Massachusetts College of Art and Design

ADA Compliance Plan 2011

ADA Compliance Plan
Consultant Services
Contract #10-08

The Institute for Human Centered Design

Water Closet

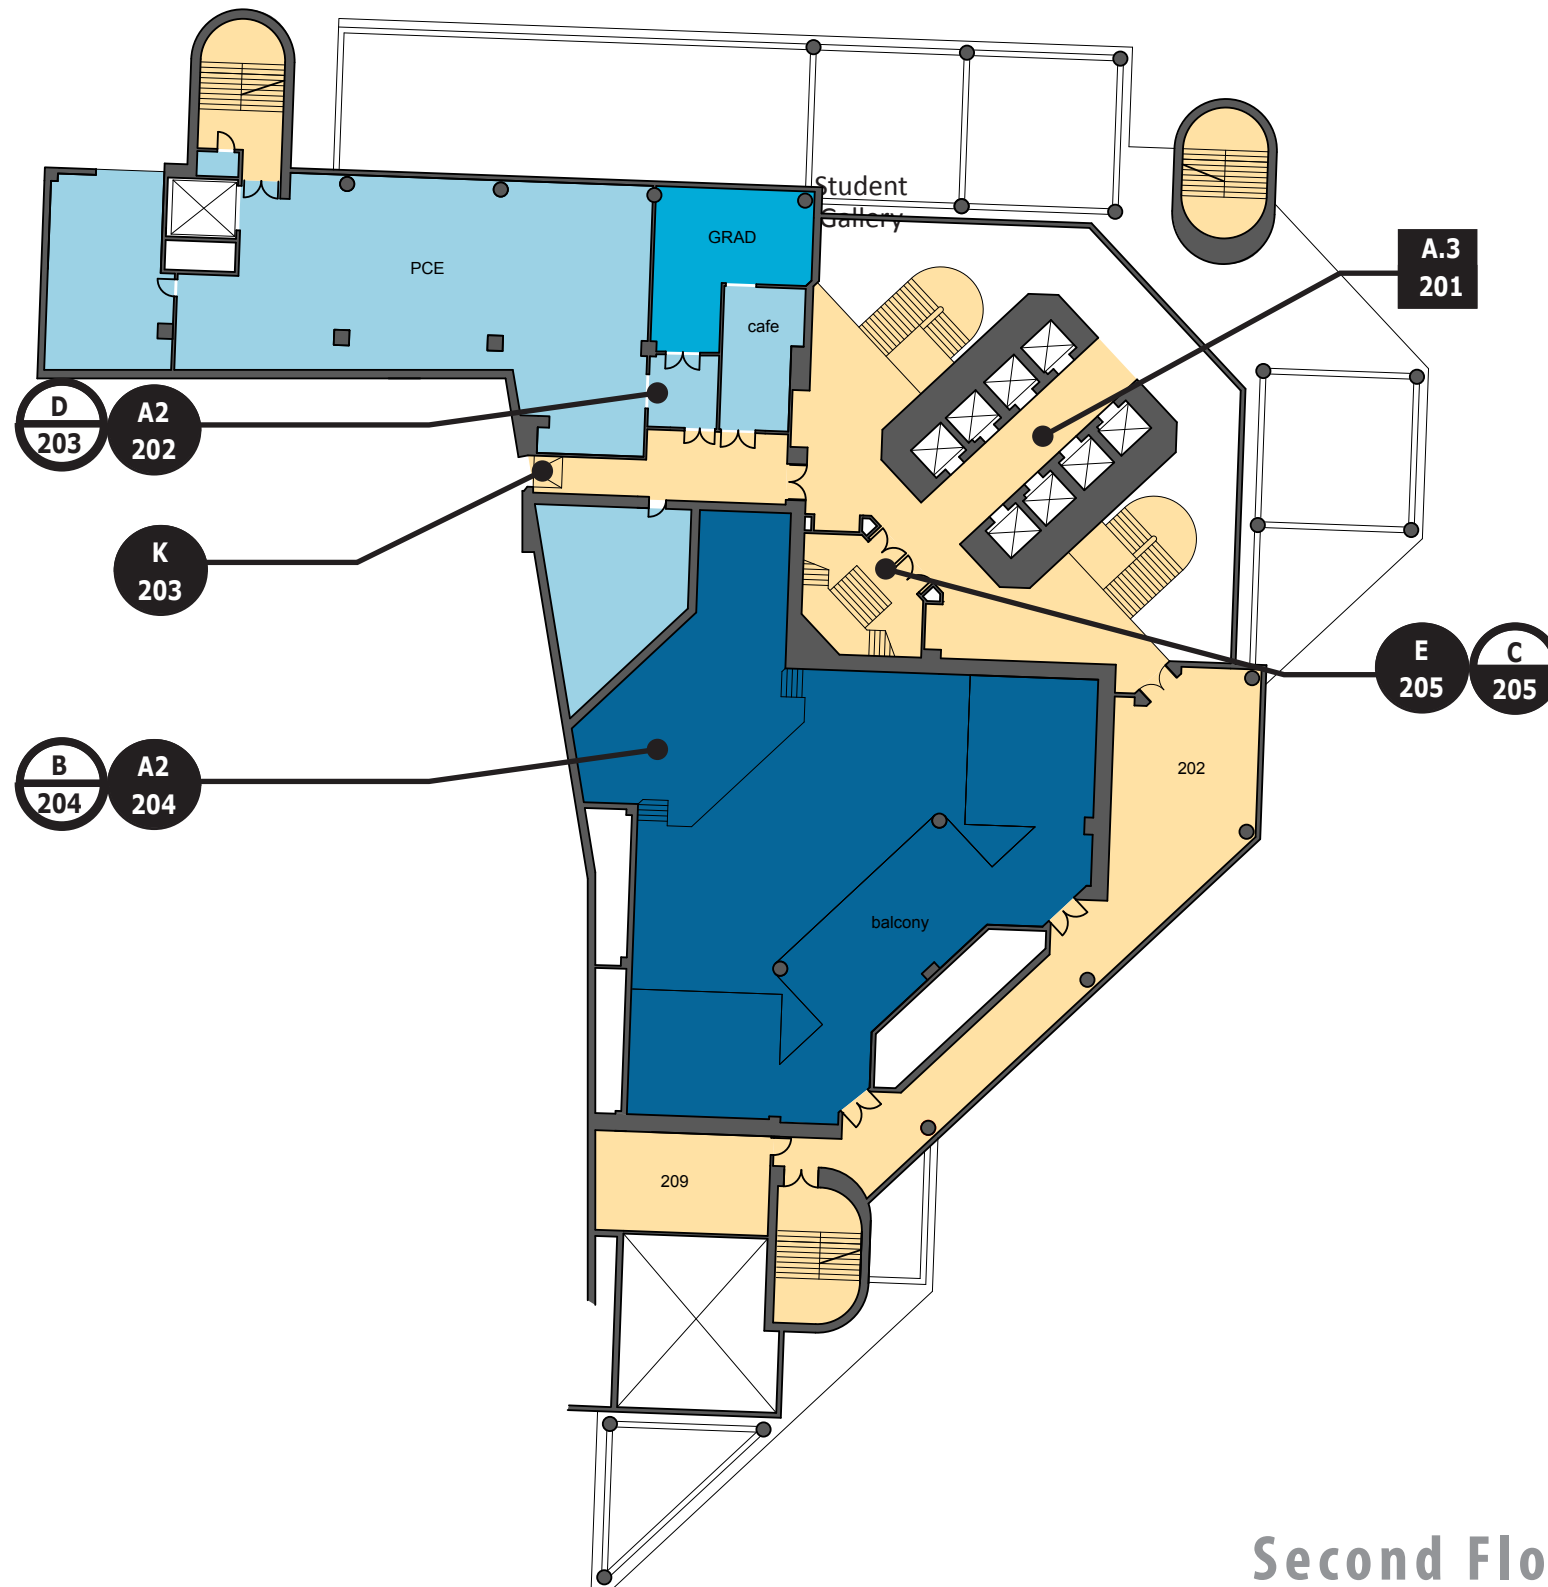
The seat of the water closet is at 20" AFF
*[See Appendix A -2010 ADA Standards
604.9.3 Water Closet Height]*

LOCATION | 203

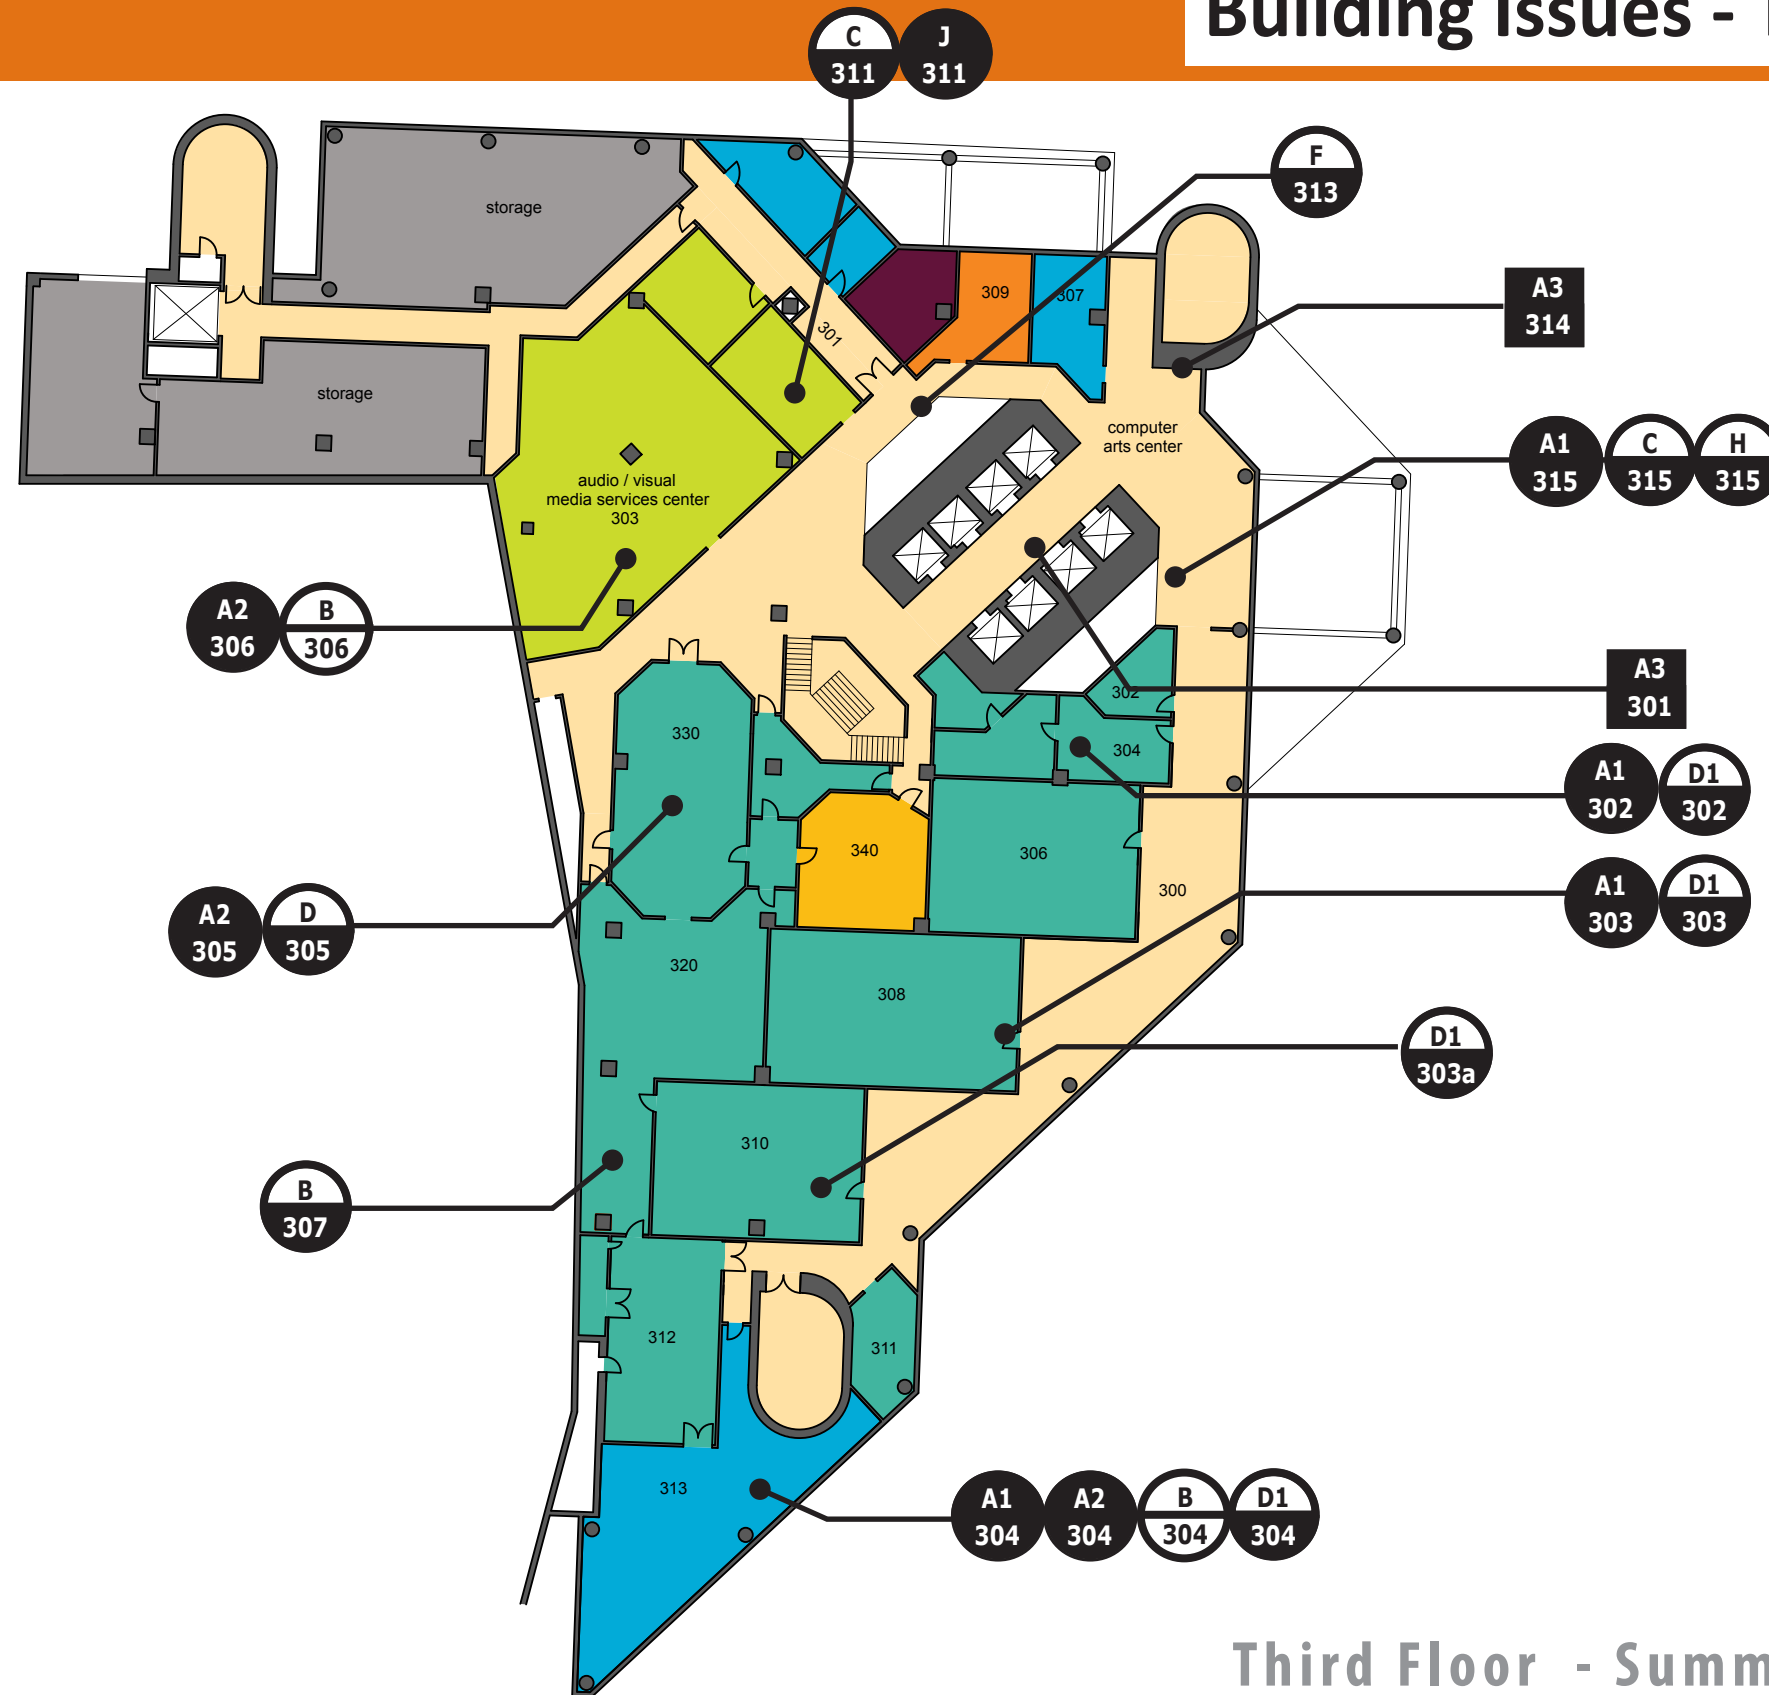
Ramp
Ramp does not meet ADA standards for accessibility for slope.
*[See Appendix A -2010 ADA Standards
405 Ramps]*

Furniture

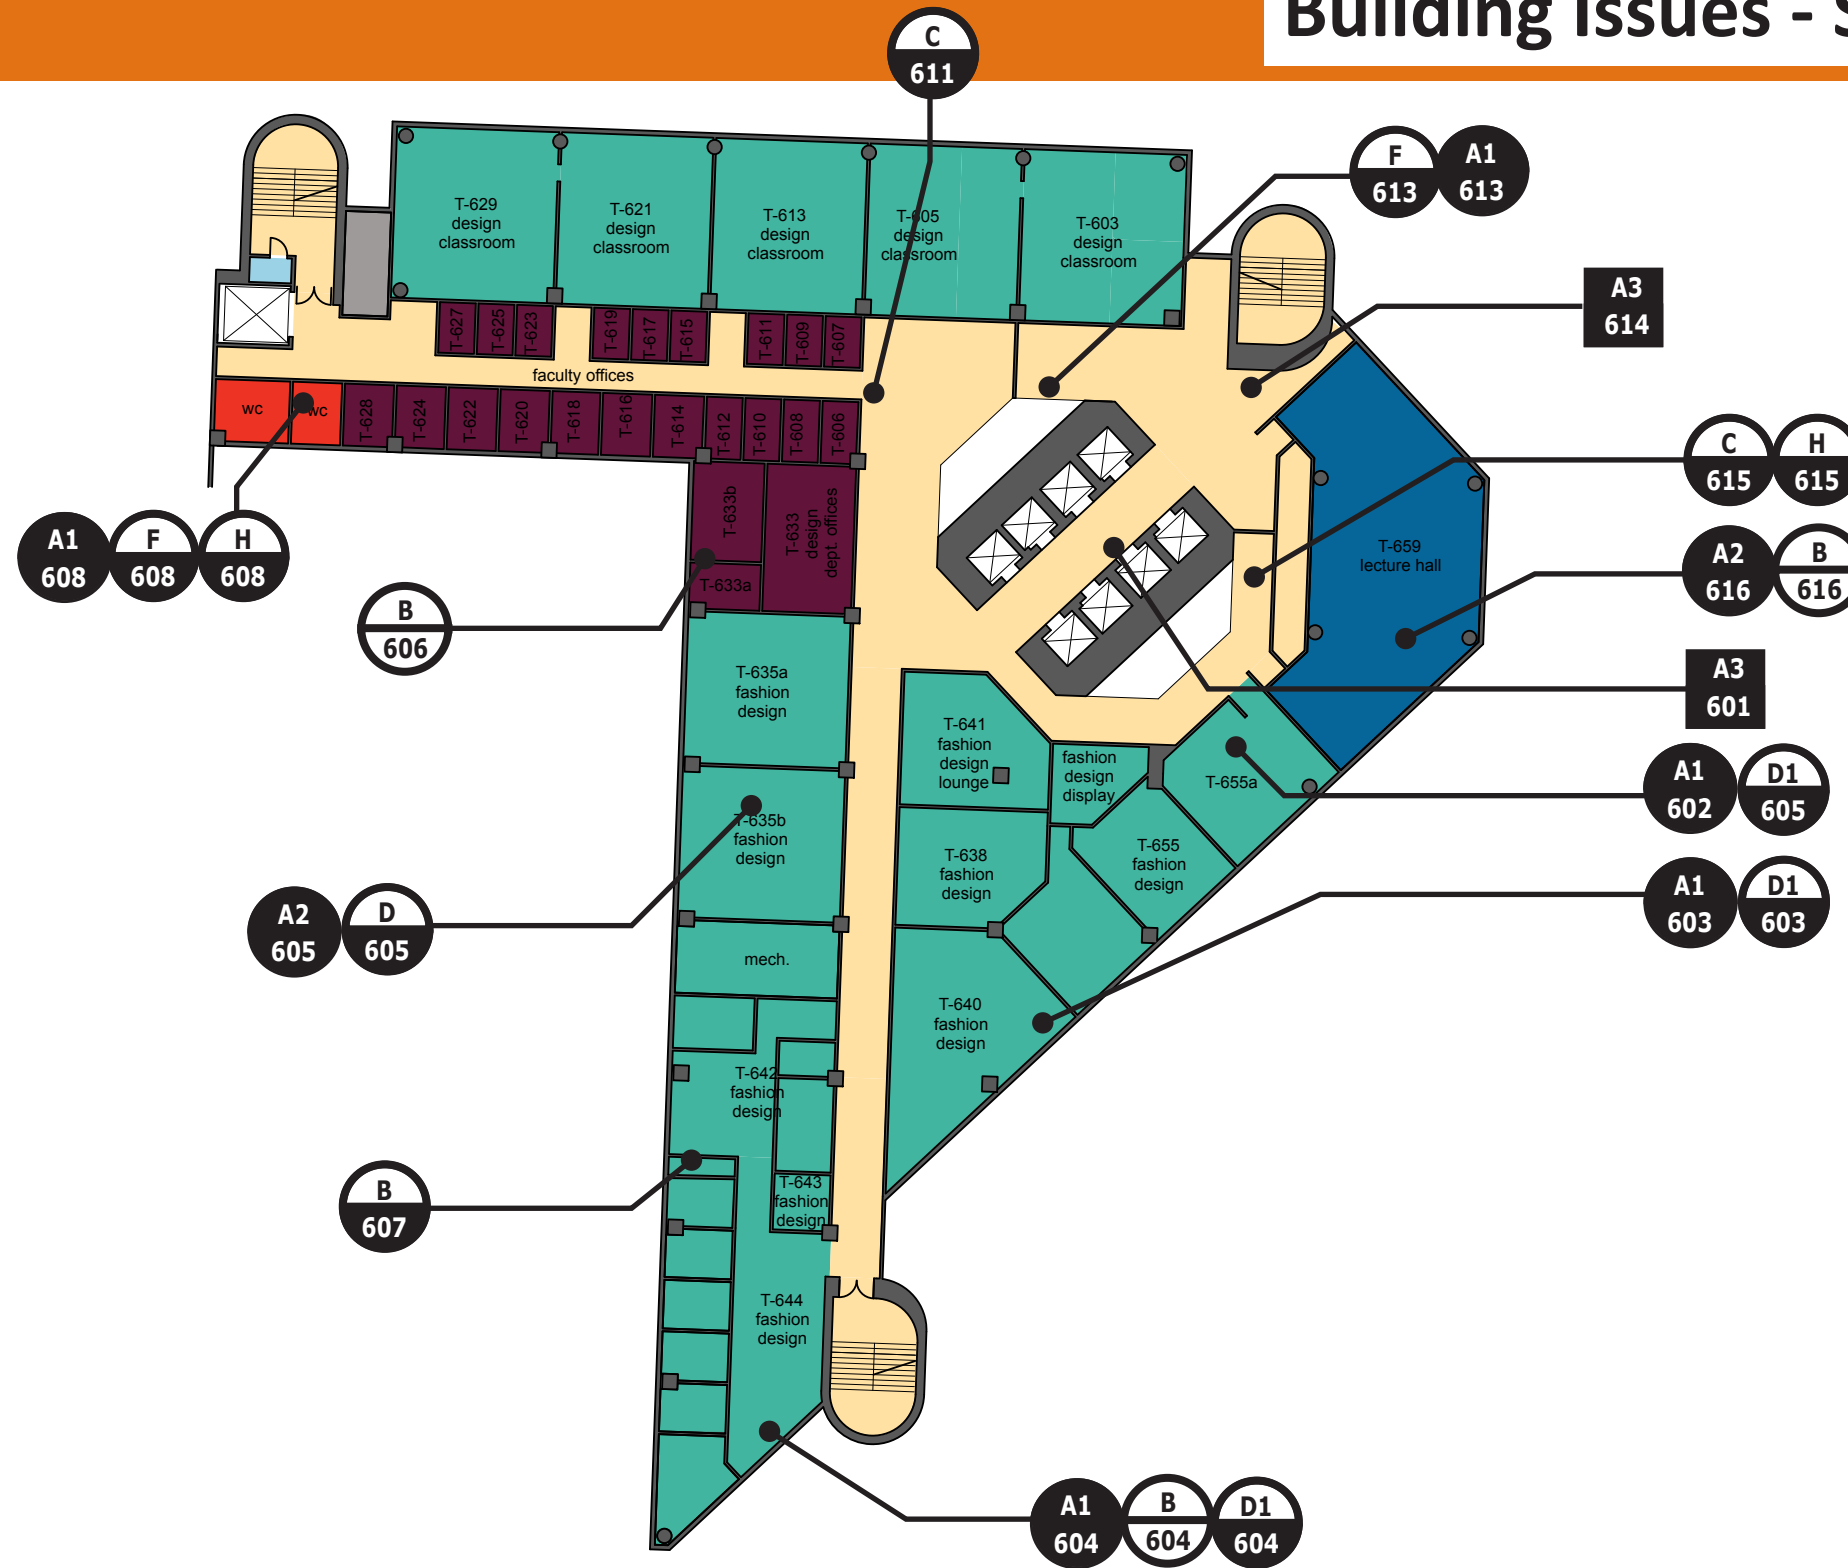
Attached desk tops cannot be used by a person using a wheelchair.

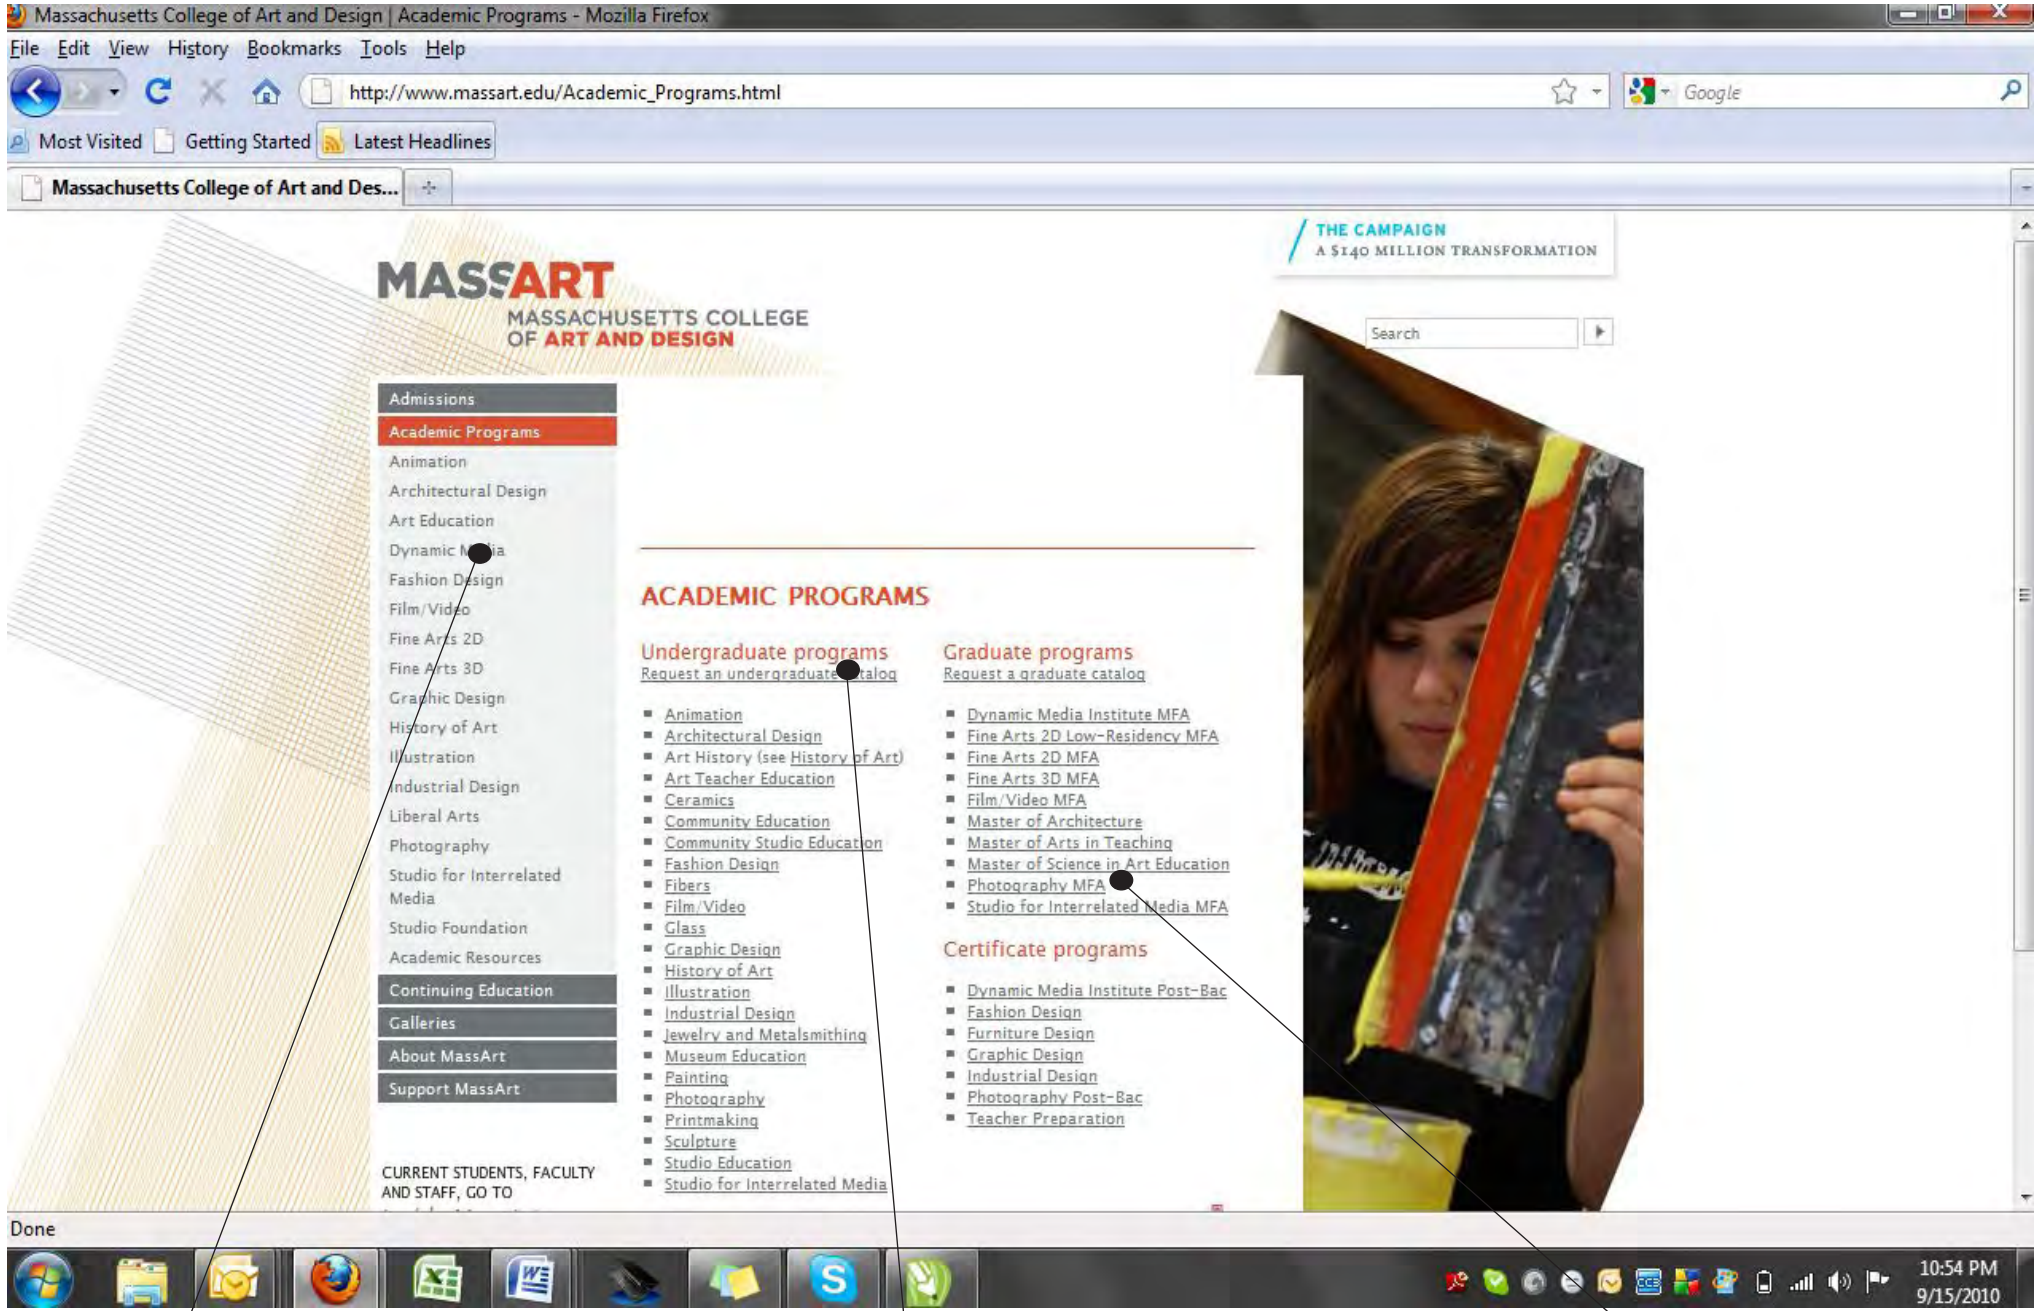
Increasing the font size slightly and or increasing the contrast would make this text more legible.

There is a nice use of line spacing which helps legibility.
